m e m o r a n d u m

SUBJECT: **Plan Case No. 2148-CW-11:** 711 Western Ave. (Mosque annex), supplemental information

SITE PLAN
CIMIC EXPANSION PROJECT (PHASE III)
CENTRAL ILLINOIS MOSQUE
711 W. Western Ave. Urbana, Illinois

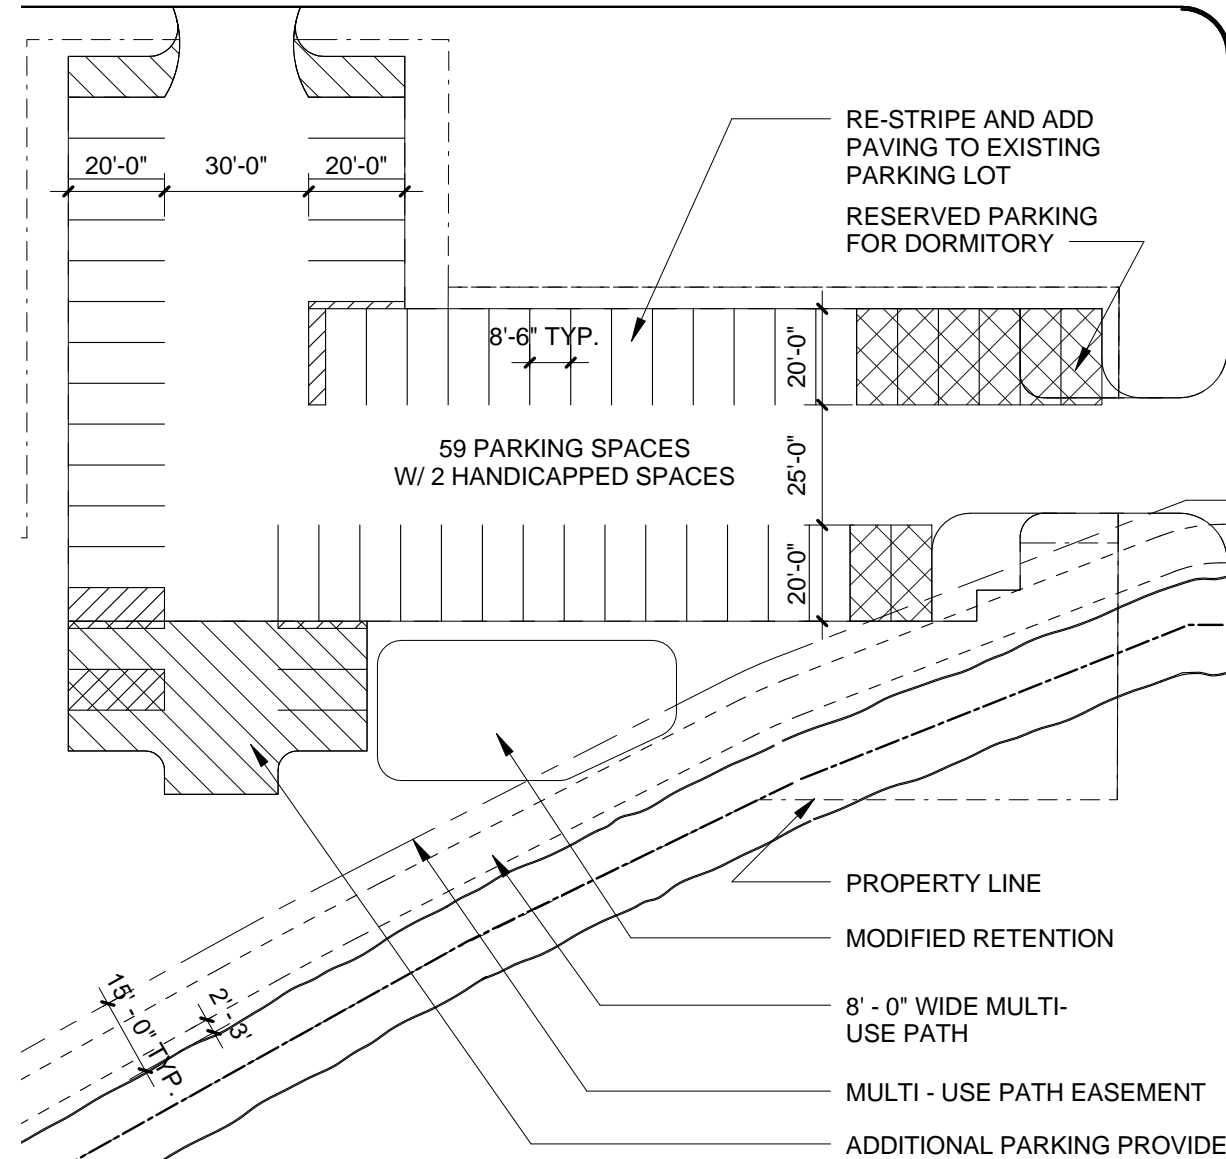
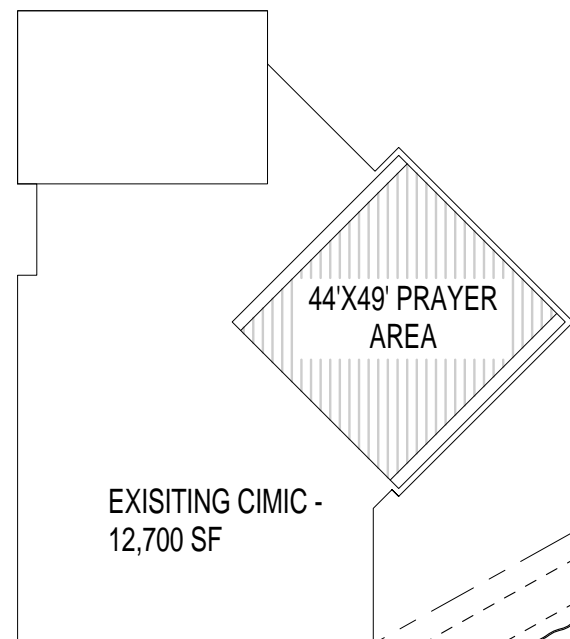
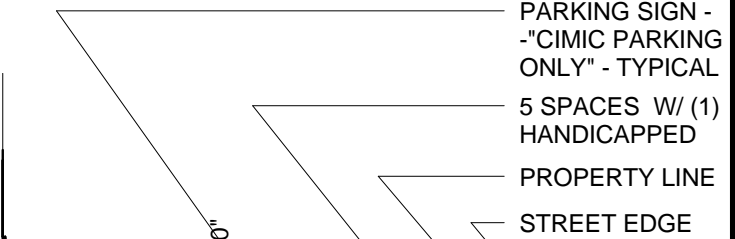
- If parking is to be provided along Western Ave. it should be shown on the site plan as parallel parking rather than 90 degree parking.
- The site plan should indicate additional parking to be created by expansion/restripping of the existing Mosque parking lot on the west side of Busey Avenue.
- The site plan should show the easement for the multi-use path bordering both portions of the Mosque campus (east and west of Busey Ave.),
- The site plan should indicate the distances between the top of the Boneyard Creek sheet pile and the proposed building to insure enough room for a future multi-use path.
- Including a generalized landscape plan, in conformance with the Boneyard Creekway Commission's recommendations, would be helpful as part of the review.

The applicants had previously provided a revised site plan to the Plan Commission. Adjustments were subsequently made based on City staff review, and a final site plan (dated Aug. 18, 2011) is attached for your review. This final site plan addresses comments made by the Plan Commission as well as those made by City staff.

TOTAL MOSQUE PARKING REQUIRED
- 50 PARKING SPACES REQUIRED FOR ASSEMBLY
INCLUDING 2 HANDICAPPED SPACES

TOTAL DORM PARKING REQUIRED
- 13 PARKING SPACES REQUIRED,
INCLUDING 1 HANDICAPPED SPACE

TOTAL CAMPUS PARKING REQUIRED
- 63 PARKING SPACES REQUIRED,
INCLUDING 3 HANDICAPPED SPACES

CIMIC CAMPUS PARKING PROVIDED
- 64 TOTAL SPACES
- 61 STANDARD SPACES
- 3 HANDICAP ACCESSIBLE SPACES

- 59 SPACES PROVIDED AT MOSQUE SITE
- 5 SPACES PROVIDED AT DORM SITE
